DESIGN <i>RT</i>	DRAWN BY <i>RF</i>	DART AEROSPACE LTD HAWKESBURY, ONTARIO, CANADA	
CHECKED <i>H</i>	APPROVED <i>H</i>	DRAWING NO. DSI 9279	REV. A SHEET 1 OF 2
DATE 04.04.22		TITLE STROBE POWER SUPPLY RELOCATION SCALE NTS	
A	04.04.22	NEW ISSUE

DART SERVICE INSTRUCTION

TO AMEND INSTALLATION DRAWING D350-604 REV. B

The purpose of this Service Instruction is to allow for relocation of power supply for the anti-collision strobe light so that the D350-604-041 Rear Locker Extender can be properly installed in aircraft modified per SB 33.05.

VIEW LOOKING OUTBOARD

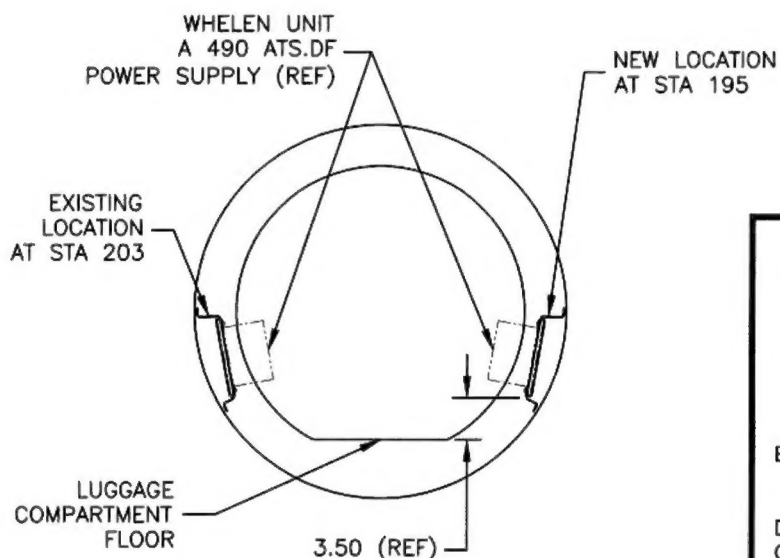
- 1) Open luggage compartment and remove protective panels.
- 2) Position and transfer Ø0.129" (3.25mm) holes from D3246-041 Mounting Bracket to skin at (LH) side of the fuselage STA 195 as shown in the sketch. Install D3246-041 Mounting Bracket using (8) 21215 DC 24.07J/MS20470AD4 rivets

- 3) Disconnect tail boom electrical cables LX10E, LX11NE and LX12E from WHELEN A 490 ATS.DF Unit.
- 4) Remove WHELEN A 490 ATS.DF Unit from the original location at STA 203, by removing (4) 22272 BC 040.008L screws.

- 5) Install D350-604-041 Rear Locker Extender per Dart Installation Instruction D350-604.
- 6) Install WHELEN A 490 ATS.DF Unit to D3246-041 Mounting Bracket using (4) MS27039-1-07 Screws And (4) AN960JD10 Washers.

- 7) Re-route Cables LX10E, LX11NE and LX12E from the (RH) side to the (LH) side of the tail boom and re-connect to WHELEN A 490 ATS.DF Unit.
- 8) Re-connect Cables LX10E, LX11NE and LX12E
